NUREG/CR-7113
PNNL-19353

An Assessment of Ultrasonic Techniques for Far-Side Examinations of Austenitic Stainless Steel Piping Welds

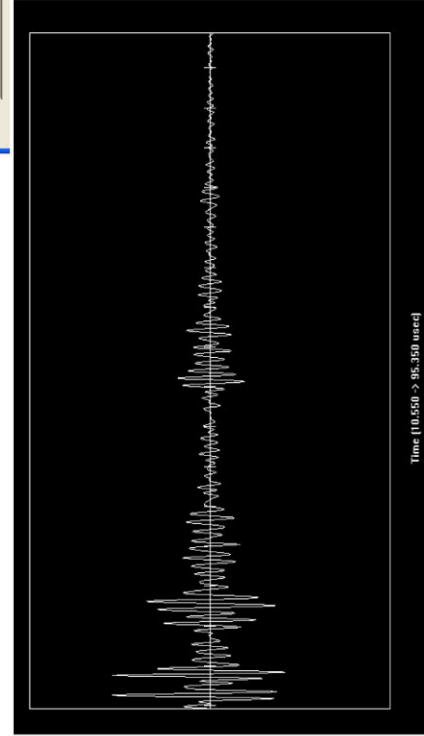
Response: 2453 (counts), -999.0 (dB)

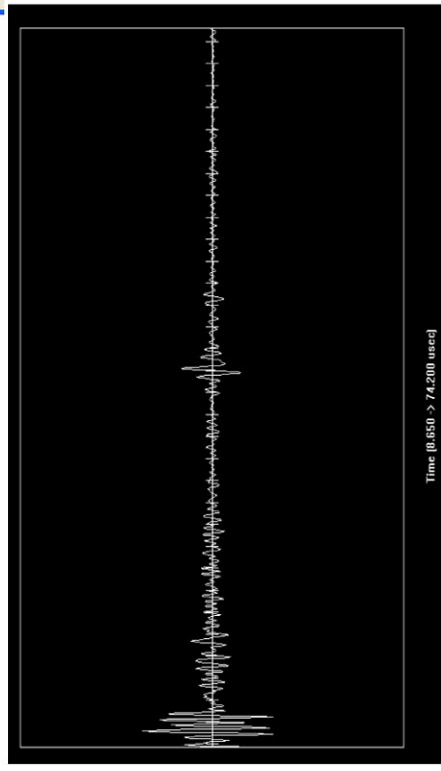
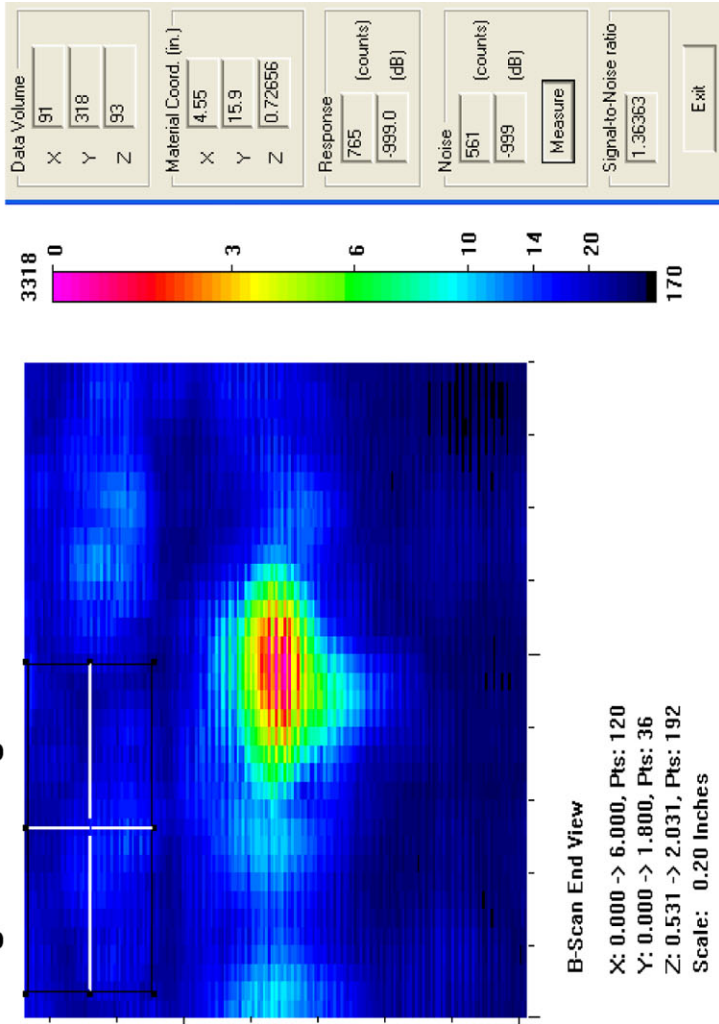
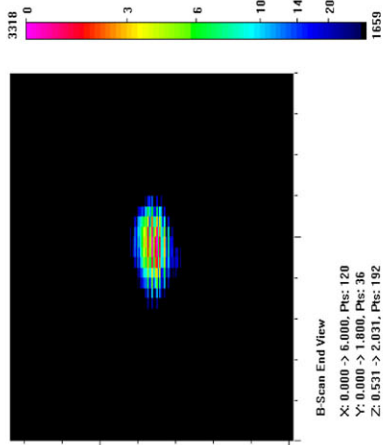
Response: 765 (counts), -999.0 (dB)

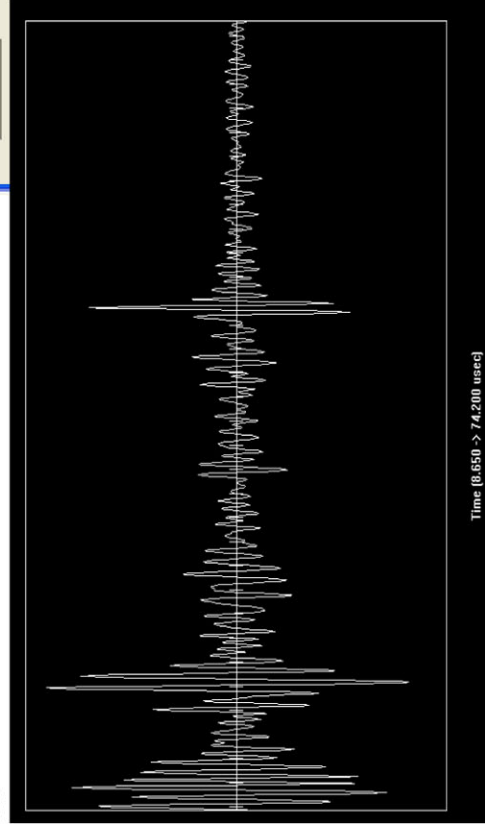
Response: 1880 (counts), -999.0 (dB)

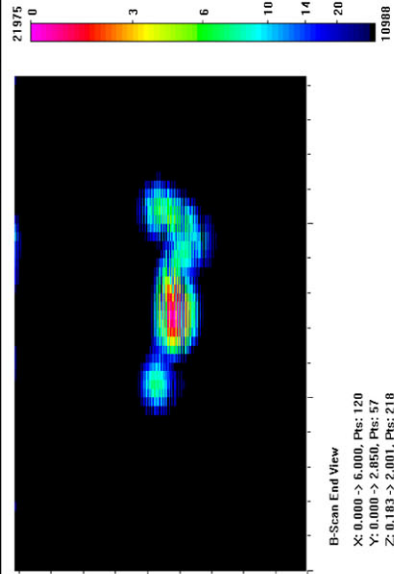
Response: 3273 (counts), -999.0 (dB)
